**Subject: Drury Centre Stage 2 (Fast Track)  
Post Transport Conferencing Modelling Update**

**JOINT WITNESS STATEMENT (JWS) IN RELATION TO:**

**Topic: Transportation**

**Figure 1: Sidra layout for NZTA Design**

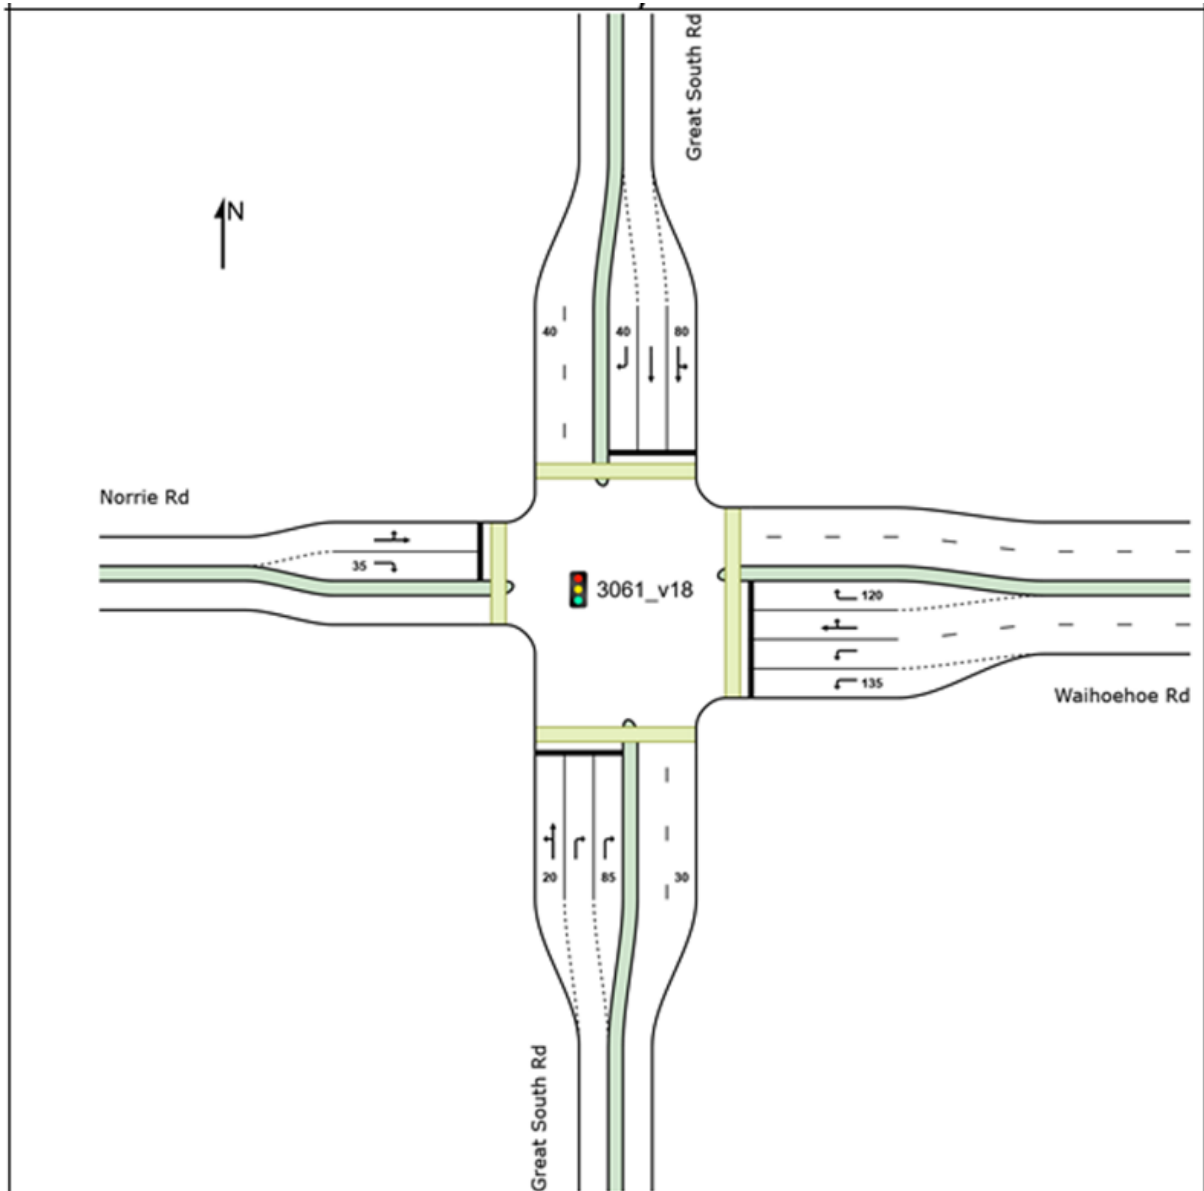
**Figure 1** below shows the Sidra layout that was tested, which represents the current NZTA intersection design.

# Agenda Item A.2(d): SH1DC Delay – Design Differences

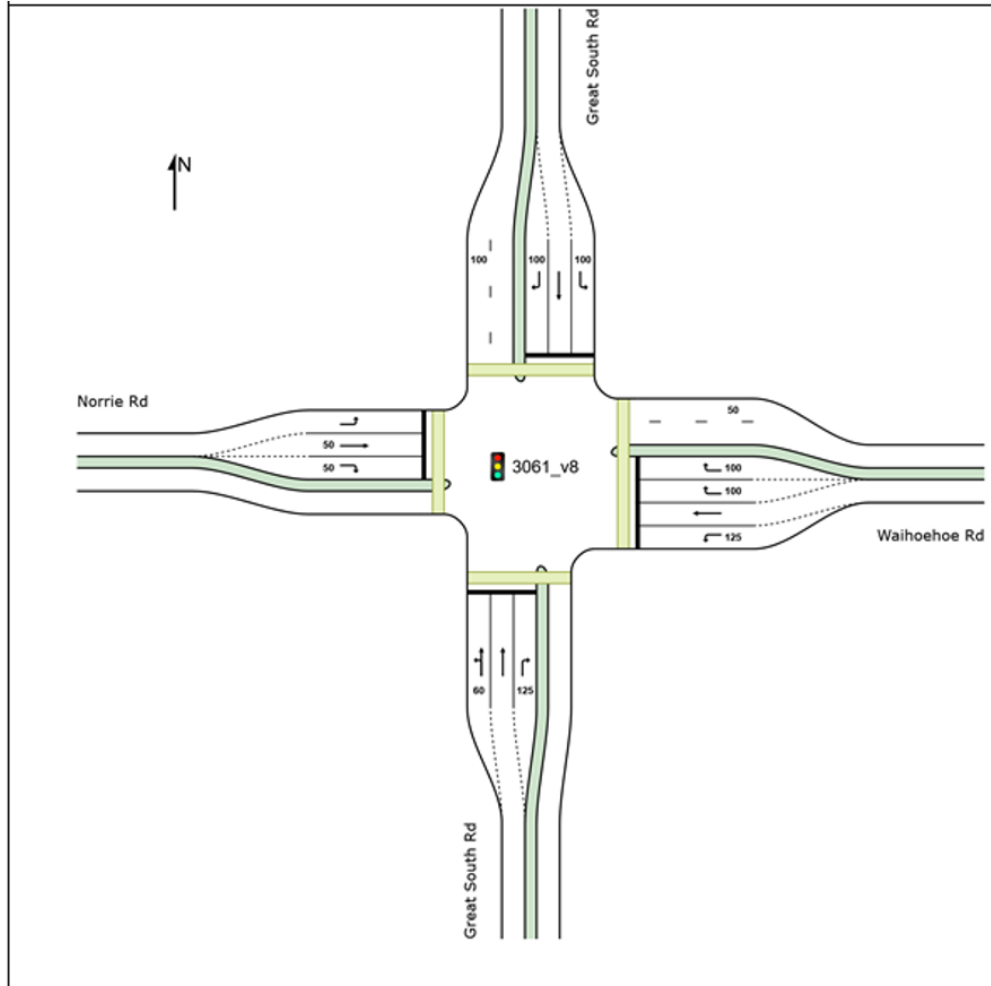
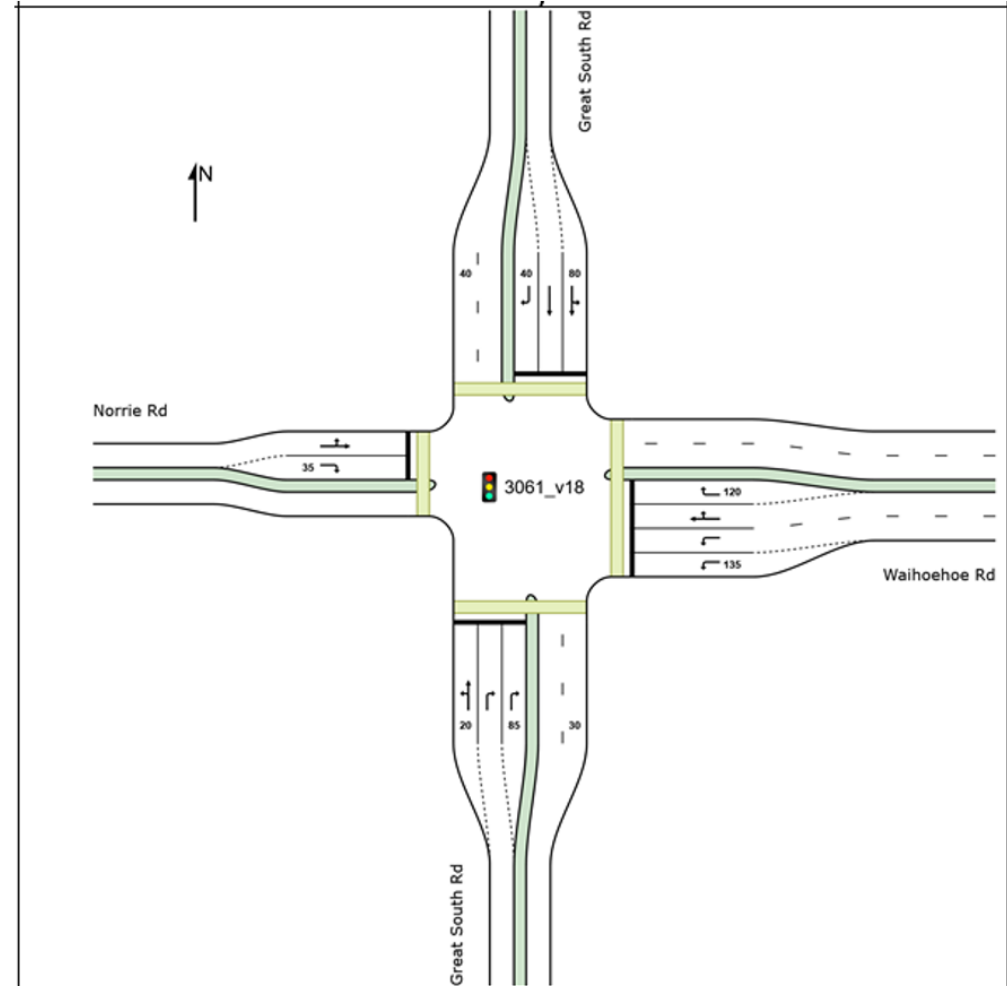
*d. The Sidra outputs on pages 11 and 14 show modelling of the same intersection, with increased traffic due to a step in the Precinct upgrade table (i.e., 2,000vph to 3,800vph). It is noted that the intersection appears to operate better with increased traffic, which is unusual. Please comment further on why this occurs and in particular:*

- i. Have the same inputs been used in both the SIDRA analysis including cycle time?*
- ii. Has anything other than traffic volumes been altered in the SIDRA analysis?*

3.5.1 DH confirms this has been addressed in the response provided on 19 September 2025 and in the discussion above about the different design of the intersection now being progressed by NZTA/AT.

# GSR / Waihoehoe Int: 2,883vph ("pass") for NZTA design, with and without SH1DC

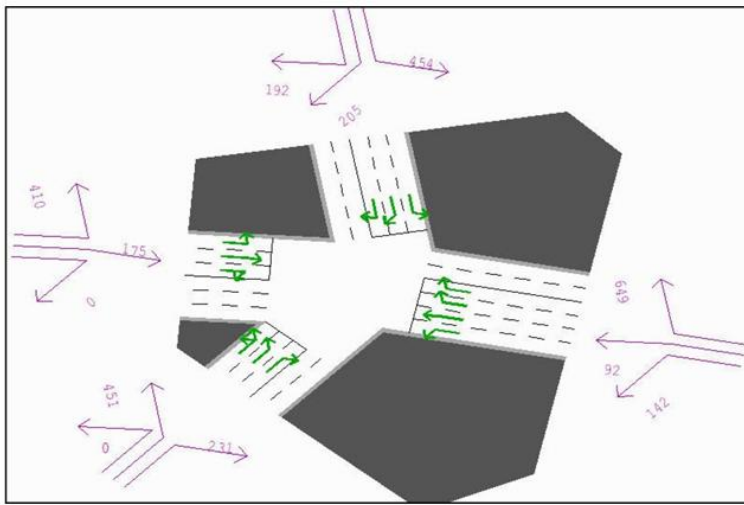
- 3.6.3 DH presented SIDRA results for the GSR / Waihoehoe intersection as per the NZTA / AT design. For a 2,700vph threshold it showed similar “pass” results with and without SH1DC. DH considers this demonstrates that the SH1DC has little effect at this stage of the development and can therefore be postponed as proposed. JP agrees with this conclusion.

- 3.6.5 PS noted that the applicant’s expert has only modelled the Waihoehoe Road / GSR intersection with the Plan Change layout and not with the NZTA/AT layout with the 3,800vph threshold. For the NZTA/AT layout, the applicant’s expert has only modelled 2,700vph threshold and with any more traffic than this, the average queue lengths extend back through the nearest intersections and are unacceptable in terms of the network criteria previously agreed. This will have significant congestion related effects not just on people travelling to and from the Metro Centre but also residents of the surrounding area, existing traffic on GSR, and the feeder bus service to the station serving areas north and west of the railway line.

Bus lanes introduced on Waihoehoe Road to address bus delays

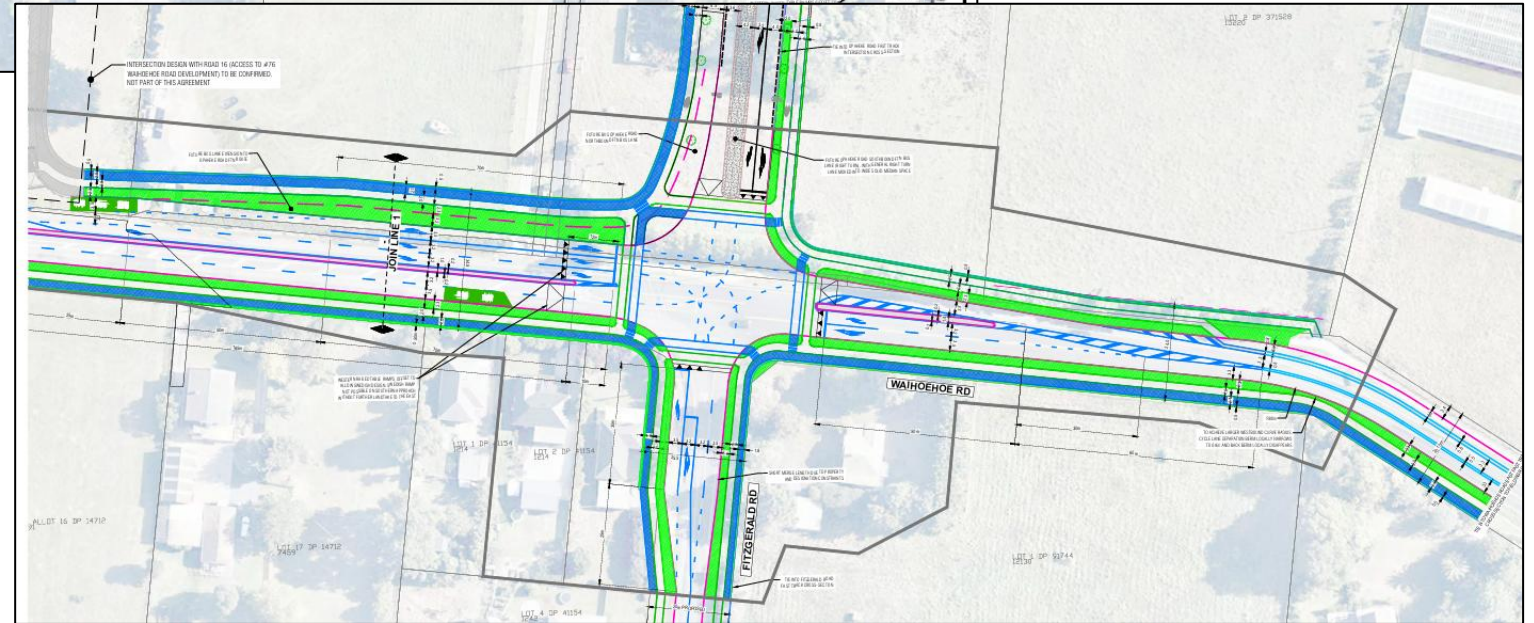
3.10.1 DH has provided additional information to address this issue (Attachment A – p. 30). LH confirms no further information is required.

# Agenda Item B: Items Marked Satisfied – Weekend Testing

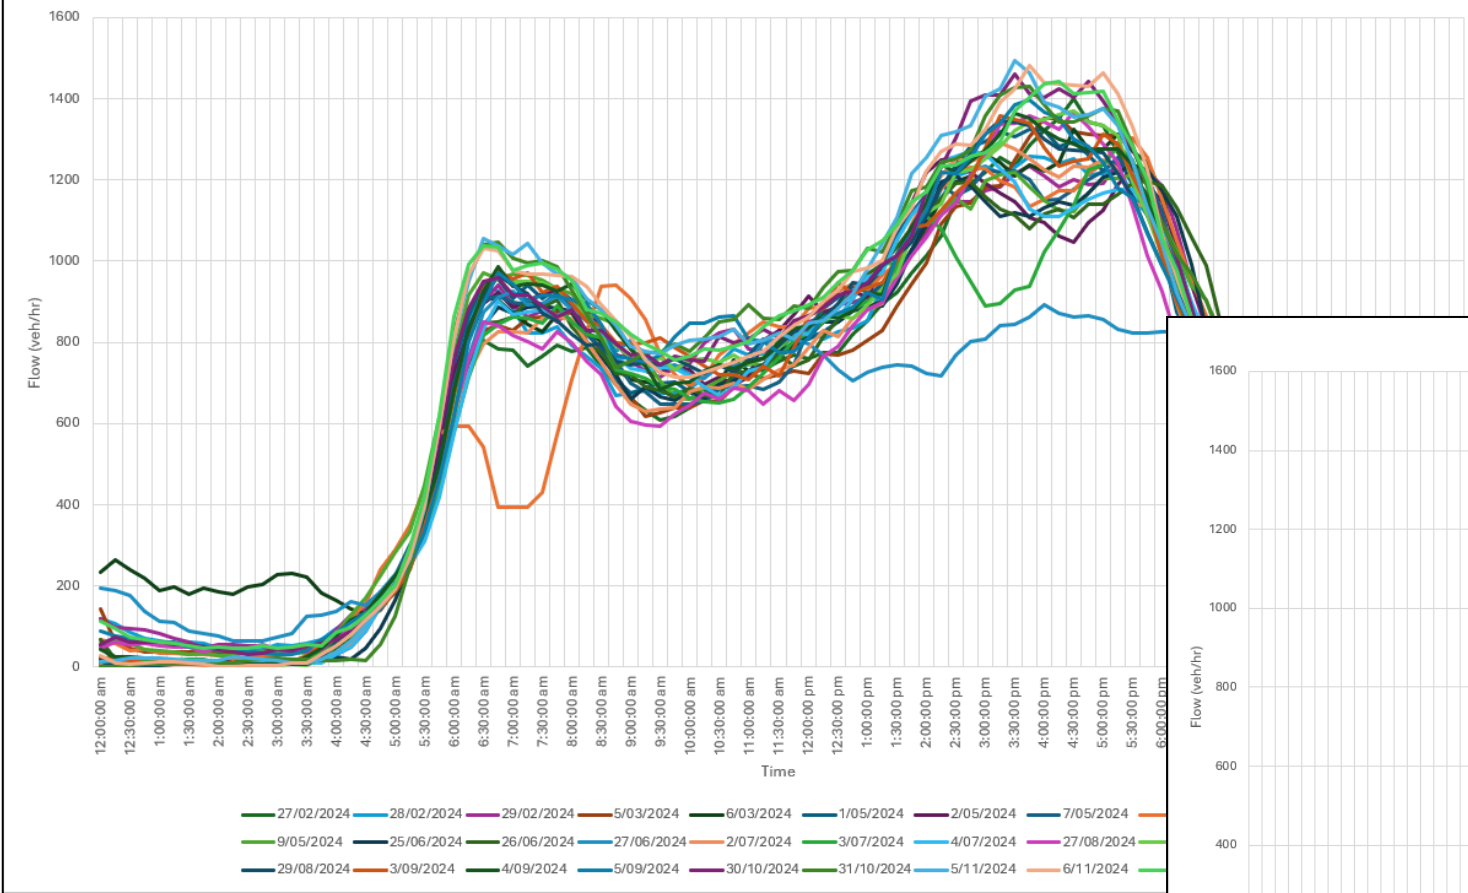
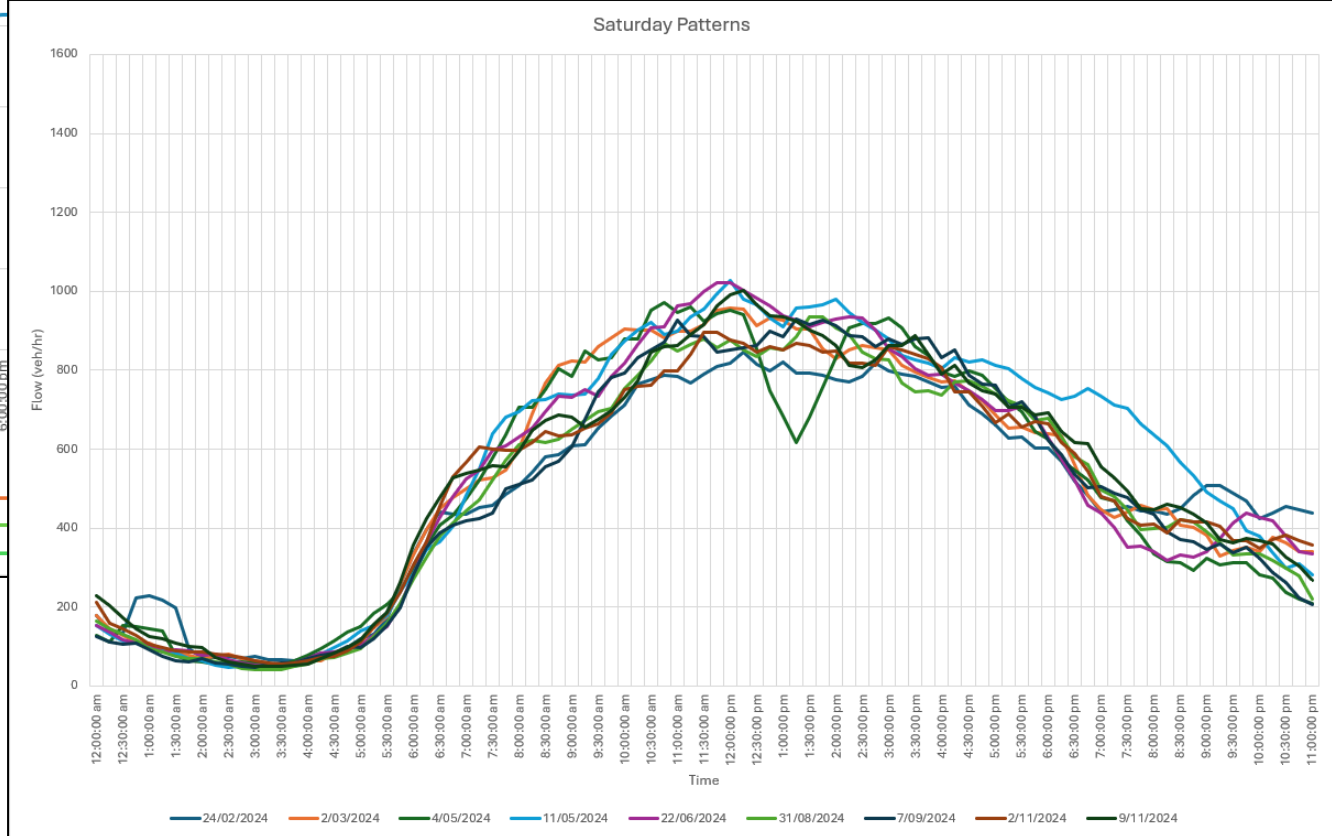
3.11.1 DH advised that there is limited information available, but what he has identified shows that there is a shallower and reduced Saturday peak in comparison to a PM weekday peak at the SH1 southbound offramp. LH considers that this demonstrates it is unlikely that the Saturday peak is critical in this location. No further discussion is required. DH and JP agree and note that the shopping trip is a discretionary trip that people can take at times when there is less congestion if they wish.

3.11.2 PS considers that because most trip generation from the applicant’s site is generated from the retail activity, that it is highly likely that there will be significant congestion in the Saturday interpeak but this has not been assessed in detail by the applicant’s traffic engineer. PS notes that while shopping trips to the retail development are discretionary, not all trips passing through the area are discretionary. Residents travelling to and from their homes will be affected by the congestion generated by the proposed development, as will existing users of GSR and the public transport feeder service to the station using GSR.

- 3.11.3 PT considers that as the nature of the development is retail-led, which means that the weekends can be congested, especially Saturday, which could trigger the threshold earlier than expected. This means that the applicant needs to get some weekend testing done and there is a significant gap in the information provided.

**Agenda Item B: Items Marked Satisfied – Vehicle Crossing Rd 6 / Rd 25**

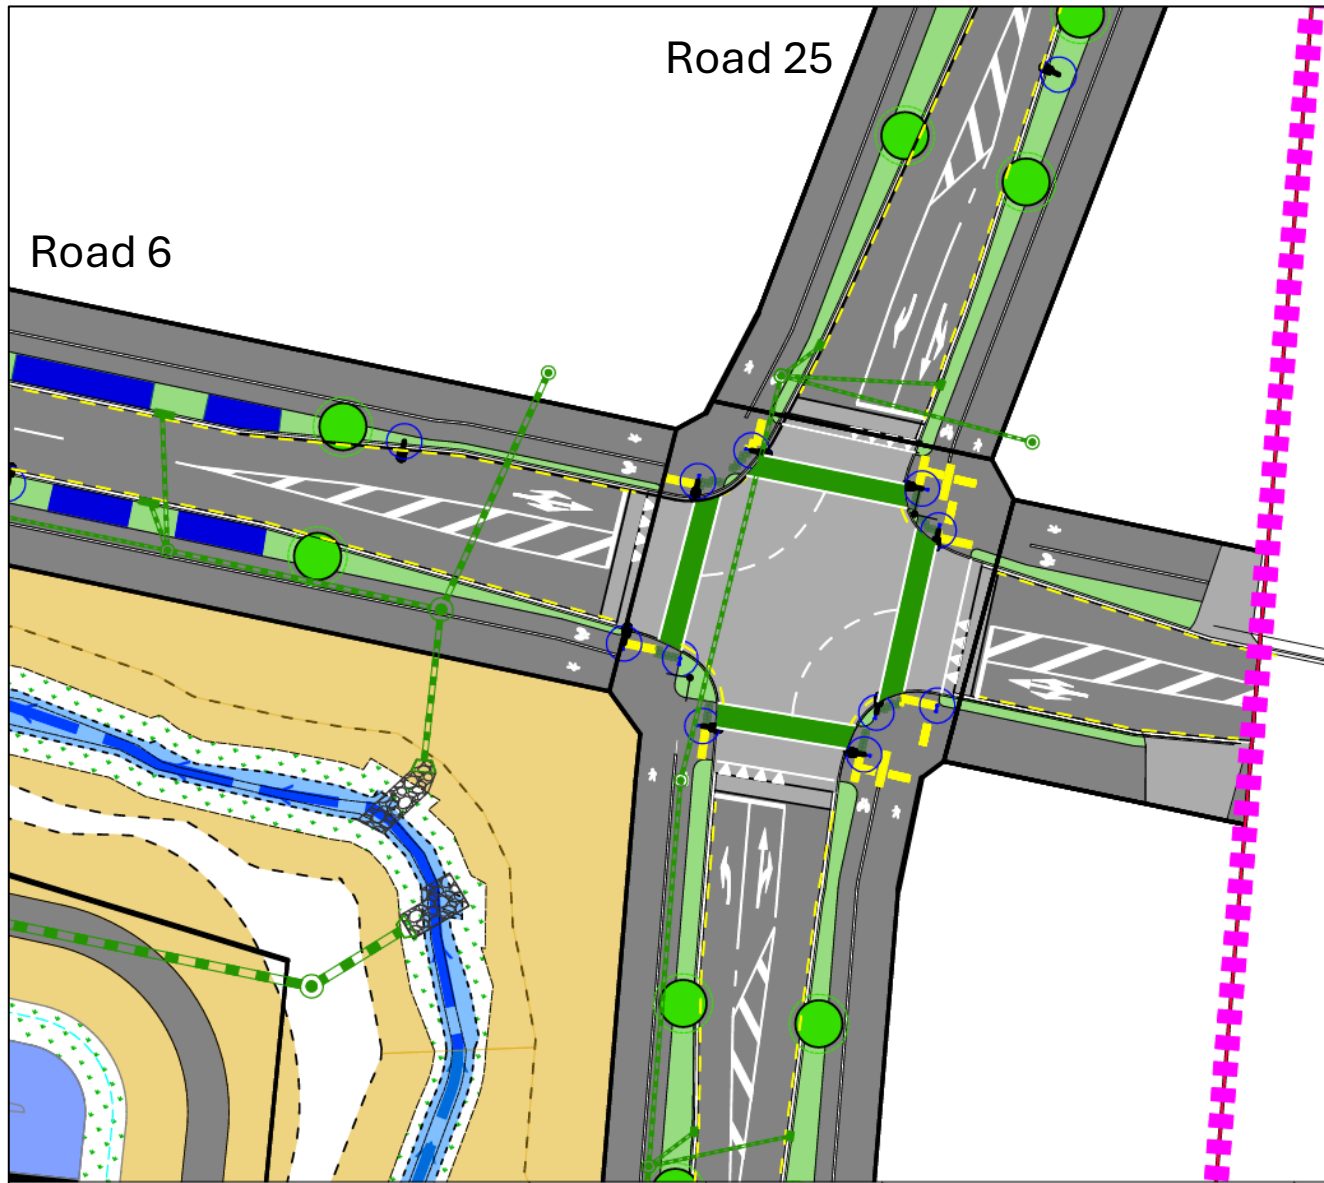
- 3.13.1 MC considers this is generally addressed based on the provided documentation (Woods) but notes that the mountable kerb proposed for the wide vehicle crossings should be reduced to provide for mountable kerbs only where the trucks track across and not in the area needed for light vehicle tracking.
- 3.13.2 NR and MW will confirm if this can be incorporated into an existing proposed condition with the design being finalised as part of the EPA.
- 3.13.3 MF, CF, and MC consider the Road 6 stub should be vested as a public road as it is shown as a collector road on the Precinct plan and will need to be extended through adjacent private land in future.
- 3.13.4 DH disagrees with para 3.13.3 and believes that the future extension can be dealt with whilst retaining private ownership of the stub road.
